**MITSUBISHI HEAVY INDUSTRIES, LTD.**  
16-5, KONAN 2-CHOME, MINATO-KU  
TOKYO, JAPAN

Docket No. 52-021  
MHI Ref: UAP-HF- 09326

**Subject: MHI's Responses to US-APWR DCD RAI No. 326-2279 Revision 0**

Responses to Request for Additional Information  
No. 326-2279 Revision 0

Figure 9.2.1-1 Essential Service Water System Piping and Instrumentation Diagram (sheet 1 of 3)

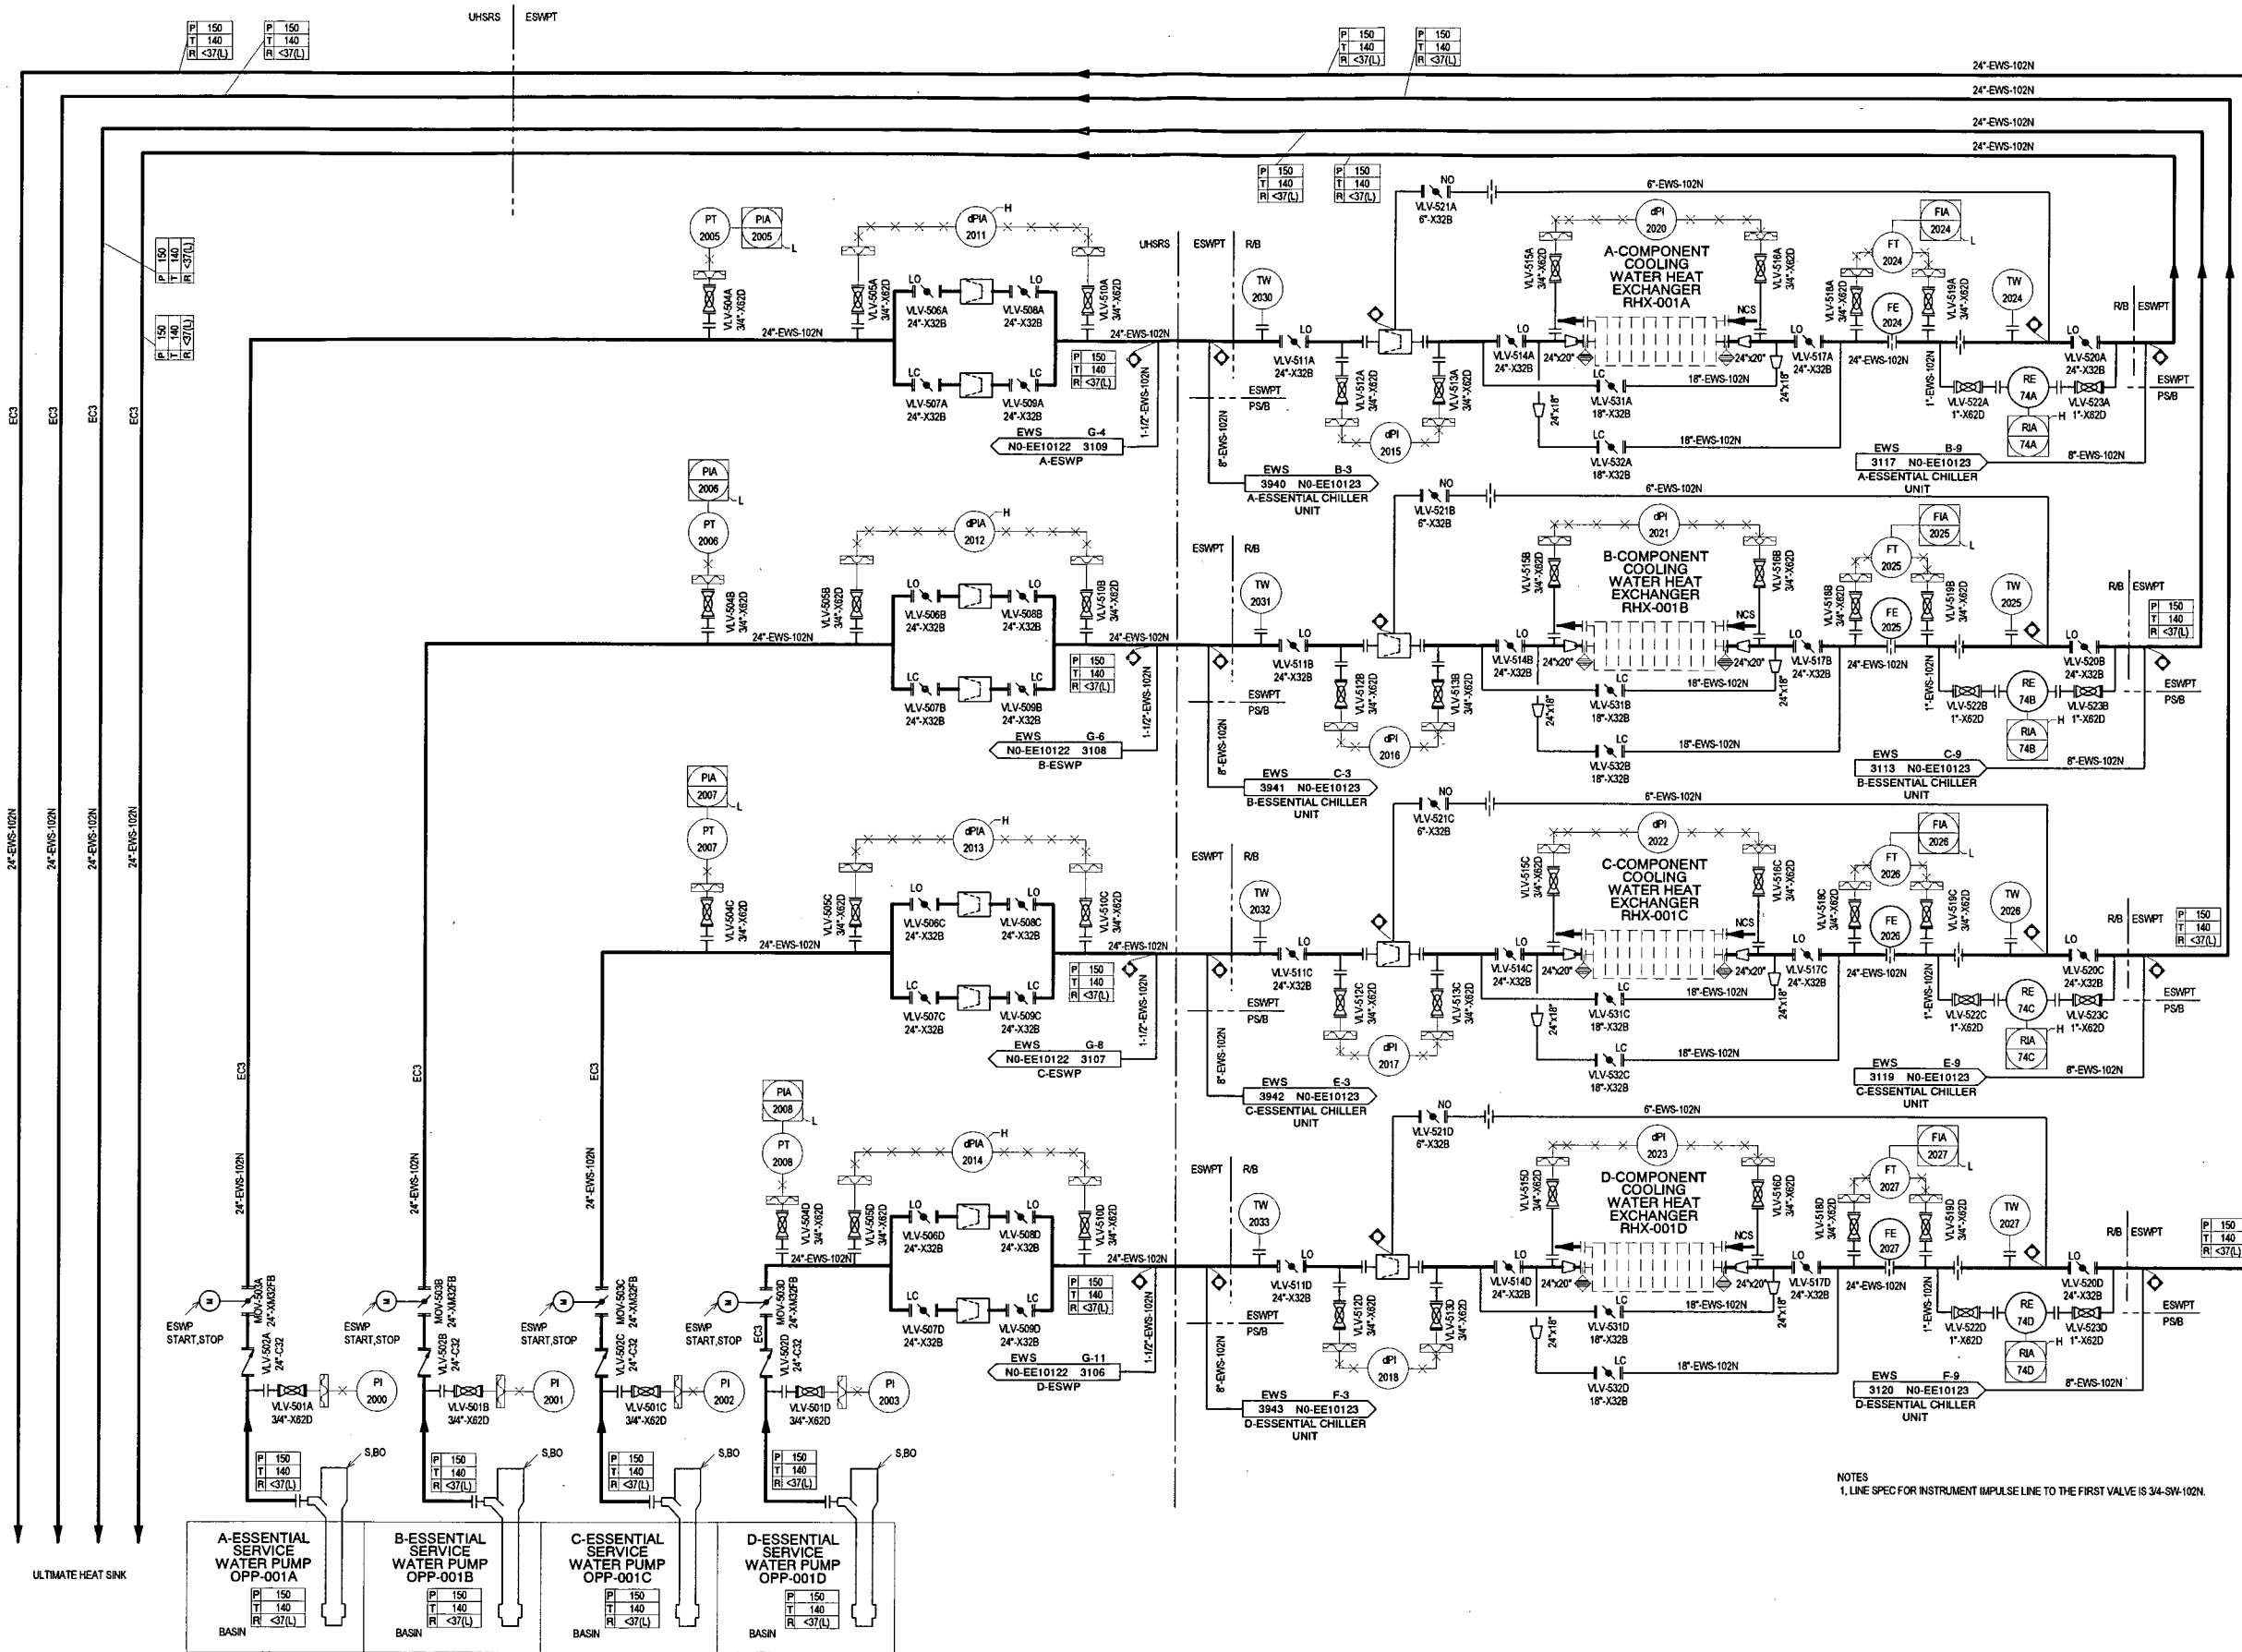
- Tier 1 and Tier 2 system drawing and diagrams of the DCD should indicate the building locations for ESWS components and indicating where the building transition occurs.

- Tier 2 of the DCD Figure 9.2.1-1, sheet 2 of 3, describes the piping classification downstream of the ESWS pump motor.
- The system descriptions in Tier 2 of the DCD did not describe the essential service water piping tunnel for trains A, B, C and D. It is not clear that some of the ESWS piping is underground or in a tunnel, or both.

- Tier 1 and Tier 2 system drawing and diagrams of the DCD should indicate the building locations for ESW components and indicating where the building transition occurs.

- Tier 2 of the DCD Figure 9.2.1-1, sheet 2 of 3, describe the piping classification downstream of the ESWS pump motor.

Tier 1 DCD Figure 2.7.3.1-1, and Tier 2 DCD Figure 9.2.1-1 will be revised to indicate the building locations, and where building transition occurs.

Tier 2 DCD Figure 9.2.1-1, Sheet 2 of 3, shows an Equipment Class 3 piping downstream of the ESW pump motor-discharging into intake basin. Therefore, it is safety-related.

Tier 2 DCD Figure 9.2.1-1 will be revised to show the building boundary locations as shown next page.

Extent of the ESW system piping located in the essential service water piping tunnel (ESWPT) is shown in revised Figure 9.2.1-1 sheet 1 of 3 in the response to RAI 9.2.1-6. Piping located in tunnels will be inspected periodically per established ISI program. A similar description is provided in Tier 2 DCD Subsection 9.2.1.2.2.5.

DCD Tier 1 Figure 2.7.3.1-1 will be revised as shown below:

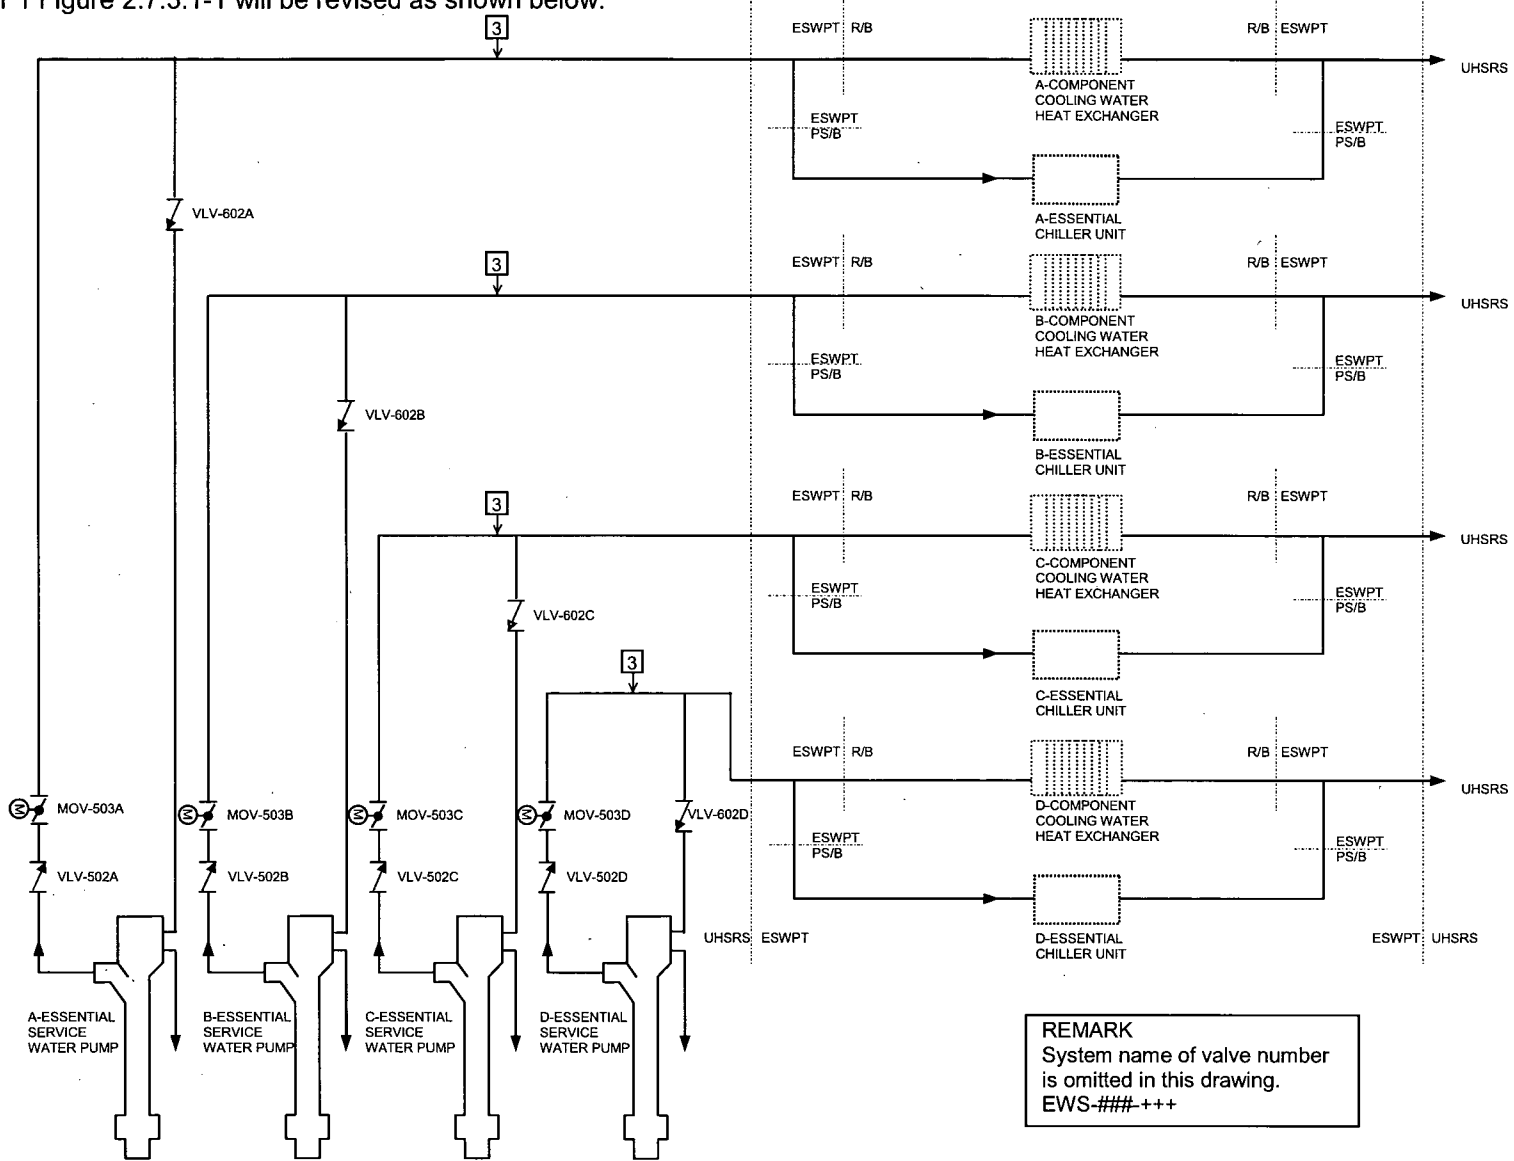
- Tier 1 of the DCD Figure 2.7.3.2-1 does not show all of the system components, for example the radiation monitors, the strainers and piping for backwashing strainers and heat exchangers. A similar level of detail needs to be provided in the Tier 1 and Tier 2 drawings of the DCD in order to meet inspections, tests, analyses, and acceptance criteria (ITAAC) commitments for verifying system configuration.

- Tier 1 of the DCD, Figure 2.7.3.1-1 does not include many of the major components of the ESWS, such as strainers, radiation monitors, check valves, and pump motor self-cooling lines, nominal pipe sizes, testing connections, and so forth. This figure should contain all of the system level detail found in the Tier 2, Section 9.2.1, and Figure 9.2.1-1. The Tier 1 Figure 2.7.3.1-1 shows a '3' in a box in four locations which should be clarified. Revise Figure 2.7.3.1-1 to indicate all the major components of the ESWS to be confirmed by ITAAC, Item 1a.

Revised Tier 1 DCD Figure 2.7.3.1-1 is found within the responses to RAI 09.02.01-28.
